Harsco Track Technologies

SERVICE BULLETIN MAINTENANCE OF WAY EQUIPMENT

BULLETIN NO: 07-008

TITLE: INTEGRAL SPINDLE MOUNTING BOLT TORQUE INFORMATION

FIGURE 1
SPINDLE MOUNTING

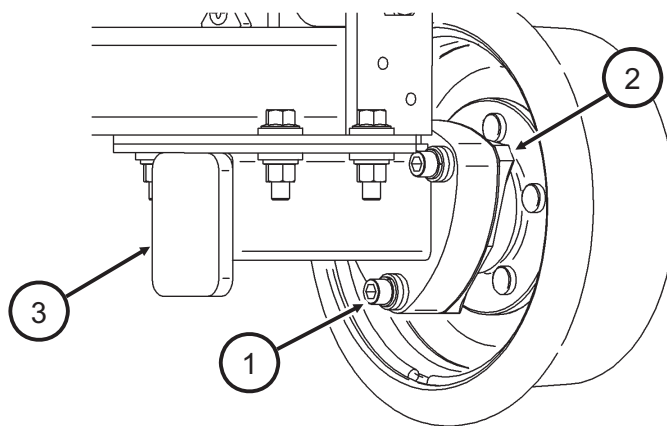
Checking Integral Spindle Torque - See Figure 1

1. Visually inspect the integral spindle mounting area and mounting bolts (1) for signs that the mounting bolts are loose. If it appears the spindle mounting bolts may be loose, the spindle (2) needs to be removed from the stub axle (3) and the insulation components, mounting bolts (1), spindle (2) and stub axle (3) inspected for damage. If necessary, replace components and then reassemble.
2. There are three integral spindle M12 x 1.75 hex socket head mounting bolts (1) per spindle (six per guide wheel unit). Torque the integral spindle bolts to 60 LB-FT (80 N-m).
3. If the integral spindle mounting bolts (1) have been over torqued, greater than 60 LB-FT (80 N-m), the insulation components may have been damaged. Disassemble the spindle from the stub axle and inspect the insulation components. Replace as needed and then reassemble. Torque the integral spindle bolts to 60 LB-FT (80 N-m).
